N1092D-01

Modification Recommended Service Note

N1092D DCA-M Sampling Oscilloscope (Quad Optical Channel)

Figure 1 Updated overlay - should say 1.4 Vpp Max

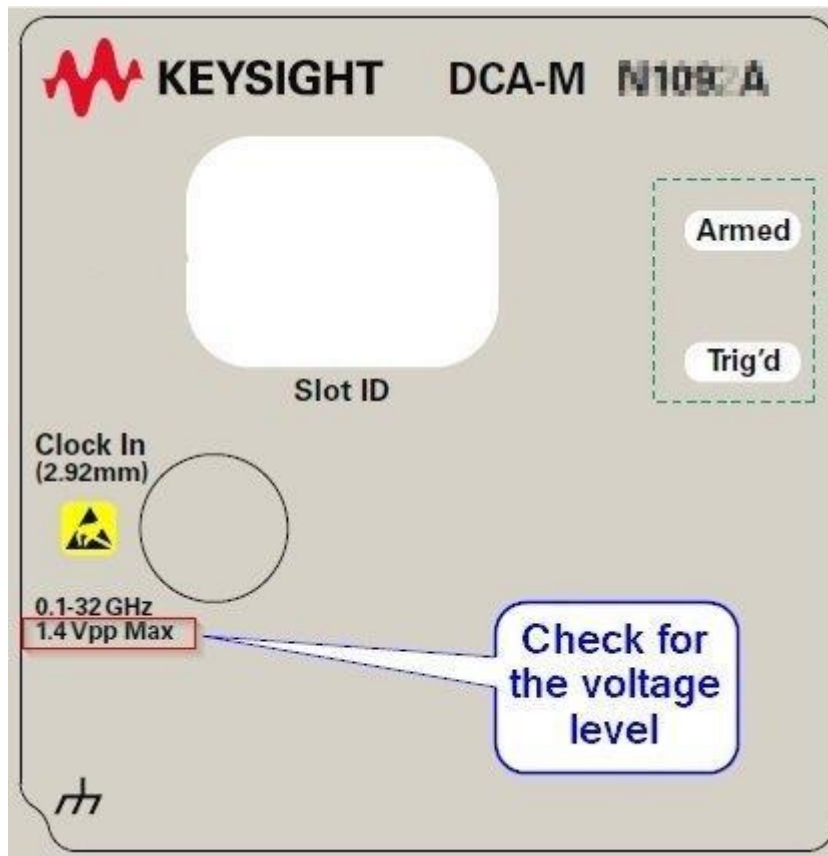
In May 2018, the clock's input port maximum signal voltage changed from 2.0 Vp-p (old value) to 1.4 Vp-p (new value). This is very sensitive circuitry and this change provides additional margin to reduce risk of damage to the instrument.

New instruments shipping after this change has the new left front panel overlay with this updated information, see Figure 1 below.

If the front left panel overlay shows 2 Vp-p (old value), remove the old overlay and replace it with the new overlay that shows 1.4 Vp-p (new value). If the customer has added any asset tags, or other customer information to the old left front panel overlay, it is recommended to send back the old overlay to the customer after it has been removed.
